AMENDMENT REPORT

CUSC Proposed Amendment CAP094

Limited Duration Transmission Entry Capacity

Amendment Ref	CAP094
Issue	1.0
Date of Issue	13 th December 2005
Prepared by	National Grid

Figure 1: Capacity available through a simple block

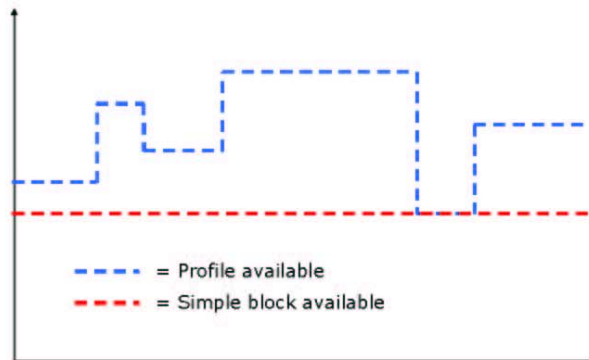
Although this alternative solution is possibly better than the present baseline we do not support it as we believe that other Working Group Alternatives are better. The simple block would minimise the amount of capacity which could be made available as it would only be able to provide the lowest level available through the period the LDTEC is requested for. This is illustrated in figure 1 below. It does not seem to make sense to force a simple block on generators when more capacity can be made available if the

generator wishes. A simple block can still be accommodated by accepting the level of capacity within the profile that provides it.

We do not accept that there are significant simplicity benefits provided by this option. There are no benefits associated with administration as National Grid has to know what the available profile is before determining what the lowest level is to offer the simple block. In terms of transparency, there may be some benefits in terms of other parties knowing the level of access which a station has available. However, parties should be able to make an assessment of this through existing operational data.

Figure 1 – MCB STTEC compared with a Profiled LDTEC

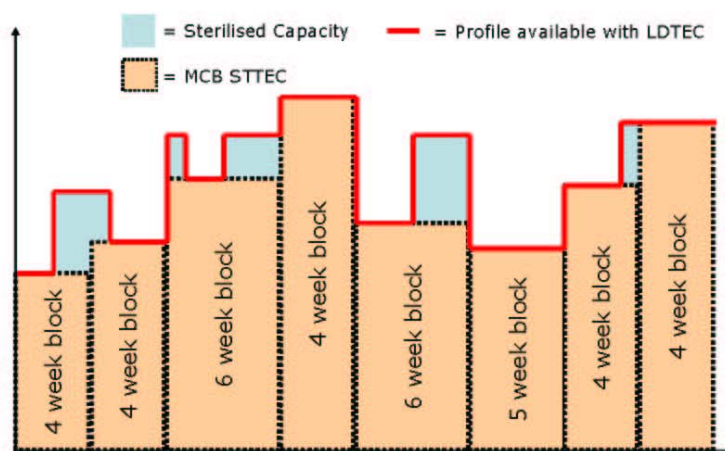
For example, the diagram in figure 1 below shows an illustrative LDTEC profile available for a generator to use. If the generator were to make a request for MCB STTEC, National Grid would have to use slots of 4, 5 and 6 weeks' duration to make up the MCB STTEC product offered. This means that certain parts of the available capacity are effectively sterilised, simply because of the lack of flexibility of the product.

As less capacity is made available, the product artificially restricts the amount of generation capacity which can be made available to the market thereby limiting the potential benefits to competition in the provision of energy and balancing services. It is also a less efficient use of the transmission capacity available.

Figure 3 – Simple Block LDTEC and MCB STTEC used in combination

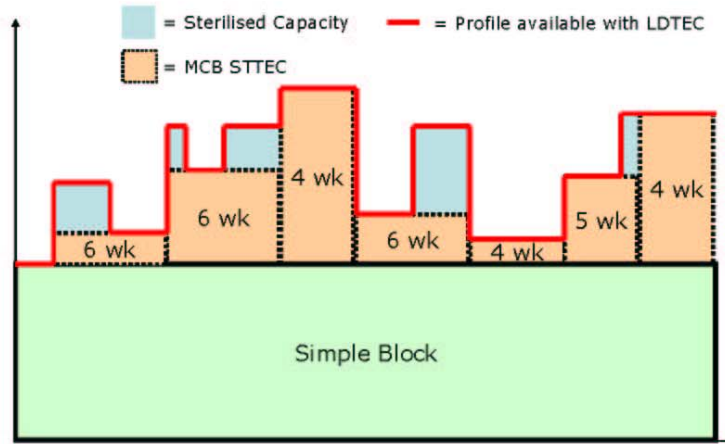
This is also an unnecessary option as a profiled block or indicative profiled block could deliver the same level of capacity and more. Again, considering the example above it is unclear why anyone would aim to go for a combination of SPB LDTEC and MCB STTEC to deliver an approximation of the profile of capacity, as in figure 3 below, when a profiled product can deliver it exactly.
